Fulbeck Avenue

# FLOOD COMPENSATION AREA DRAINAGE VERIFICATION REPORT

For New Residential Development

6706-RGP-ZZ-00-RP-C-0501 P2

Figure 1 - Overlay of FCA design and topographical survey in AutoCAD

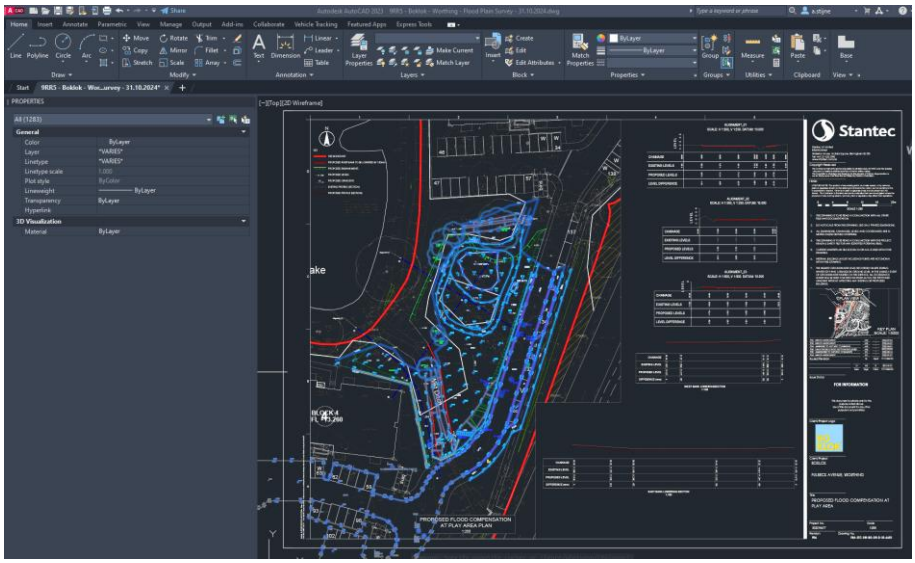
3.2.2 The extents of the as-built flood compensation area broadly matches the designed extents. The as-built FCA extends slightly further north, up to the bank of the north boundary ditch, and does not include the 'cut out' around the RPZ of tree T.109. The overlay in Figure 2 shows the design earthworks in green, with the constructed gravel path and play area hatched for clarity. The north boundary ditch is shown in orange.

3.2.5 The review of the CAD overlay and supporting photographs has verified that the FCA has been built to the designed size.

Figure 4 - Comparison Alignment 01 levels

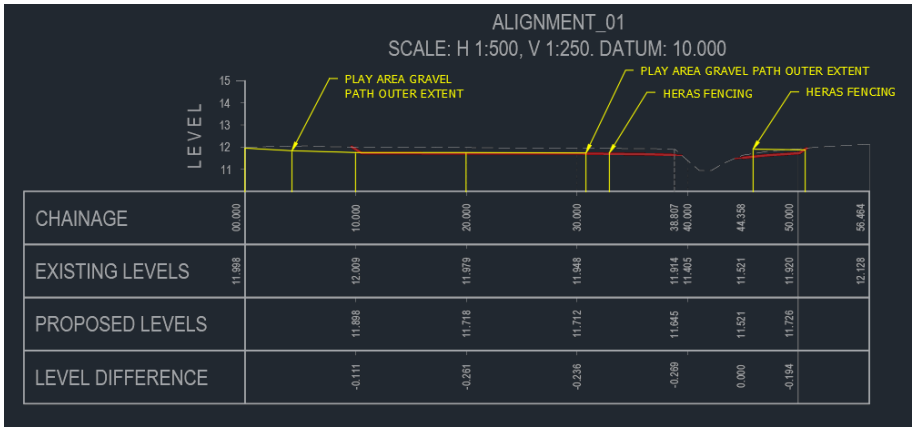
3.3.3 Figure 4 shows the FCA has been extended to the north (Ch. 0 – 10) as also described in paragraph 3.2.2. Figure 5 shows the levels have been more gently graded (~1:19) to meet the back of the access road, compared to the design earthworks (1:3). This can also be seen in Figure 3.

Figure 6 - Comparison of East Bank Lowering levels

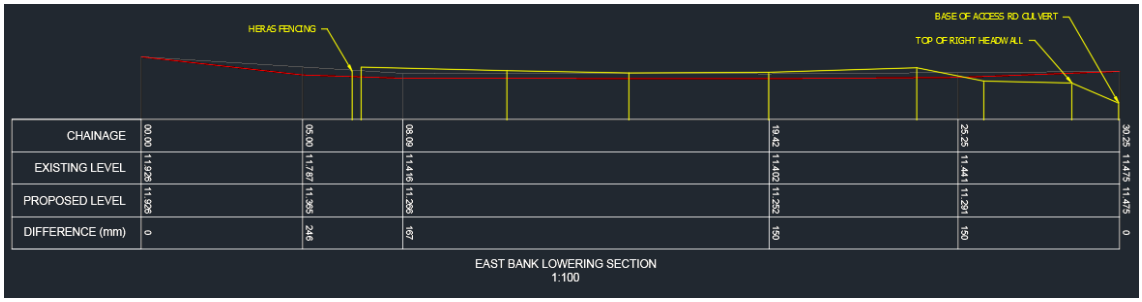
3.3.4 Figure 6 shows the lowering of the levels of the east bank of the "Wet Ditch" do not appear to have been undertaken, with the exception of the downstream extent which has been regraded to tie-in to the new Access Road culvert.

3.3.5 The north FCA has been generally constructed to the design levels, with the exception of the lowering of the East Bank levels. This, in addition to the slackened earthworks grading, will result in a reduction in storage volume, however this is considered to be small in comparison to the overall capacity of the FCA.

**It is recommended that the south FCA is reprofiled to the design levels in order to provide the design storage volume adjacent to the watercourse. It is recommended that the East Bank of the Wet Ditch is also lowered to the design levels.**

Figure 9 - Comparison Alignment 03 levels

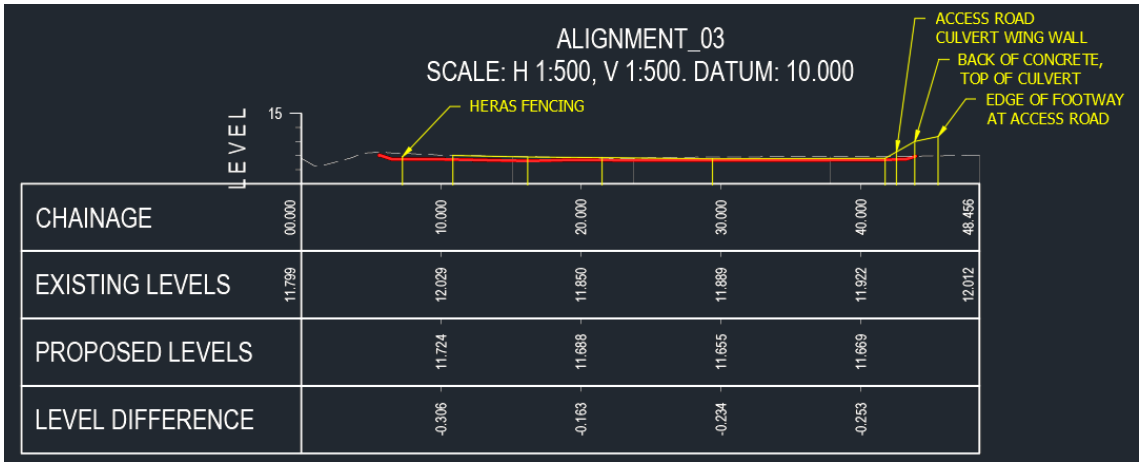
3.3.7 The area to the south of the "Wet Ditch" was proposed to be regraded, to form the south FCA. Figure 9 shows the level comparison of the south FCA along Alignment 3.

3.3.8 Figure 4, Figure 7, and Figure 9 shows the as-built levels of the south FCA are similar to the existing levels, and the 200-300mm lowering has not been achieved. Figure 10 shows the levels of the west bank of the reconstructed "Wet Ditch" appear similar to the design levels. Overall, the south FCA as constructed is considered unlikely to contribute to the functional storage volume.

4.1.5 The topographical survey shows that the revised as-built levels are within the expected construction tolerances of the proposed design levels. Following the remediation works, the Flood Compensation Area now provides the designed storage volume.
